Access Compliance Report

Public Rights-of-Way

(Curb Ramps)

Intersection ID: 7486	Main Street: TRYON_ST	Cross Street: OWEN_ST	Location: NW
ADA ID: A84A25AE9B96	Ramp Type: Perp	Initial Pass/Fail: Fail	Overall Compliance: No
Severity Score: 12.5			
Codes/Mitigation Info/Possible Solution		Field Measurements/Component Compliance

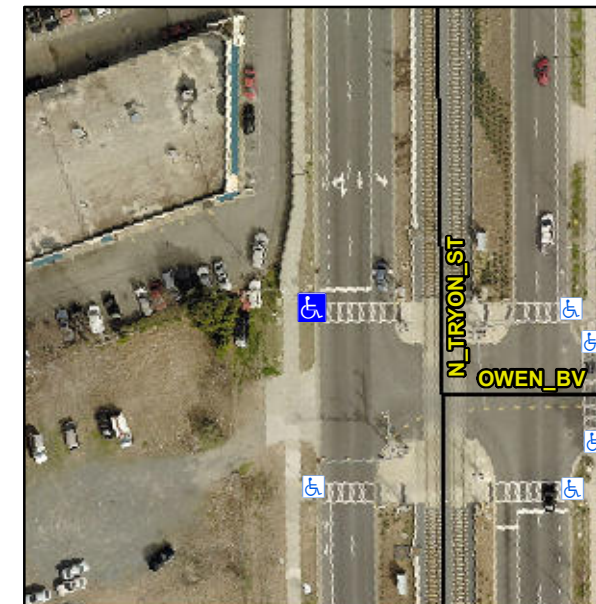
R304.2.2

Compliance	Description	Data	Compliance	Description	Data
N/A	Ramp Length (in)	97.0	No	Ramp Slope (%)	8.9
Yes	Ramp Width (in)	94.0	Yes	Ramp XSlope (%)	1.0
N/A	Flare Type LT	N/A	N/A	Flare Type RT	N/A
N/A	Flare Slope LT (%)	N/A	N/A	Flare Slope RT (%)	N/A
N/A	Flare Traversable LT?	N/A	N/A	Flare Traversable RT?	N/A
N/A	Landing Length (in)	N/A	N/A	DWS Provided?	N/A
N/A	Landing Width (in)	N/A	N/A	DWS Contrast?	N/A
N/A	Landing Slope (%)	N/A	N/A	DWS Length (in)	N/A
N/A	Landing X Slope (%)	N/A	N/A	DWS Full Width?	N/A
N/A	Landing Curb? (Y/N)	N/A	N/A	DWS Offset (in)	N/A
N/A	Shared Landing?	N/A			
N/A	Gutter Ponding?	N/A	N/A	Gutter Slope (%)	N/A
N/A	Gutter Lip Ht (in)	N/A	N/A	Gutter X Slope (%)	N/A
N/A	Painted X Walk1?	Yes	N/A	Painted X Walk2?	N/A
	X Walk 1 Direction	To E		X Walk 2 Direction	N/A
N/A	X Walk 1 Width (in)	106.0	N/A	X Walk 2 Width (in)	N/A
	X Walk 1 Slope (%)	2.3		X Walk 2 Slope (%)	N/A
	X Walk 1 X Slope (%)	0.1		X Walk 2 X Slope (%)	N/A

Remove & Replace Entire Ramp.
